**ADDENDUM 01 TO THE  
CONTRACT DOCUMENTS**

**NRDA CAILLOU LAKE HEADLANDS  
(TE-100)**

**LOUISIANA COASTAL PROTECTION  
AND RESTORATION AUTHORITY**

**AUGUST 20, 2015**

MARSH FILL GRADE STAKE, MONITORING SYSTEM, AND WARNING SIGN DETAILS

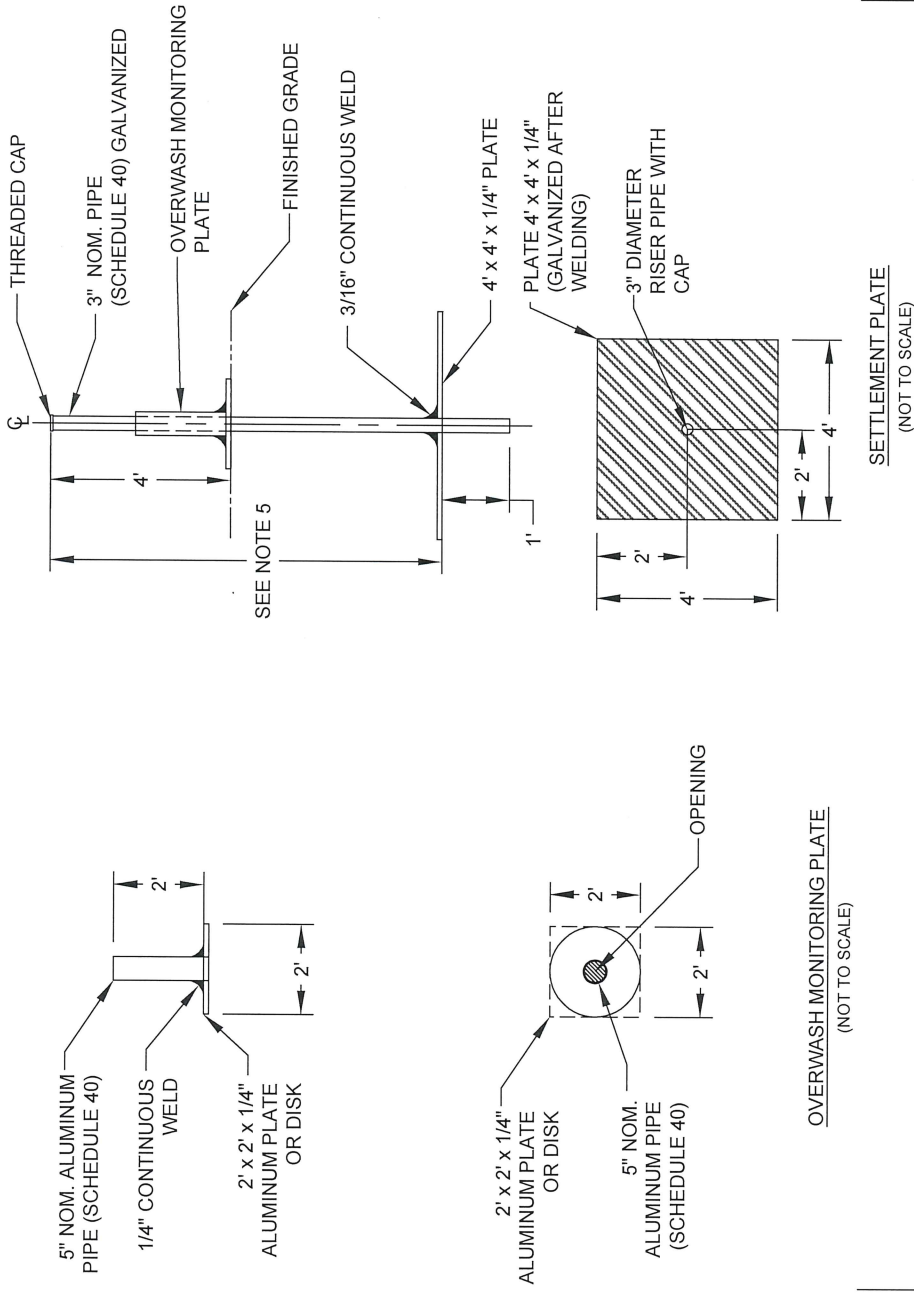
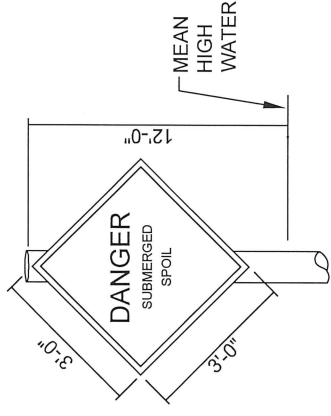
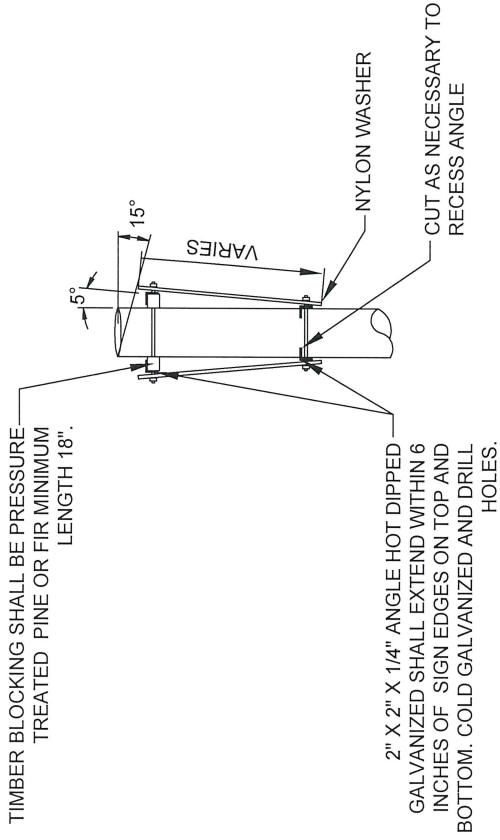
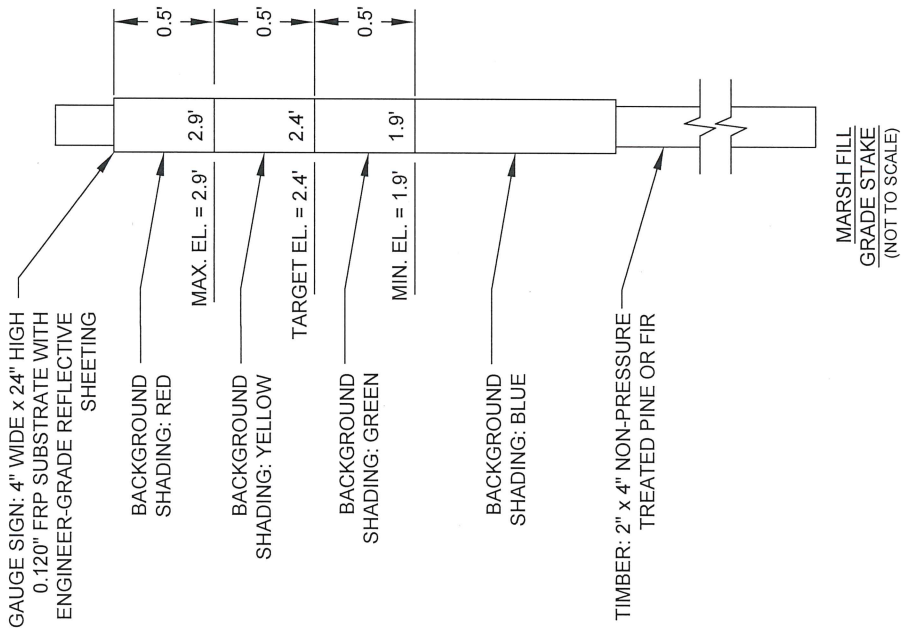
- 7.1 SHEET 34 – MARSH FILL GRADE STAKE, MONITORING SYSTEM, AND WARNING SIGNS: Revised elevation markings on Marsh Fill Grade Stake depiction. Refer to Attachment D for revised Construction Plan Sheets

REV.	DATE	DESCRIPTION
01	08/13/2015	REVISED MARSH GRADE STAKE ELEVATION CALLOUTS AND LOCATIONS ON THE FRP SUBSTRATE
		MTP
		BY
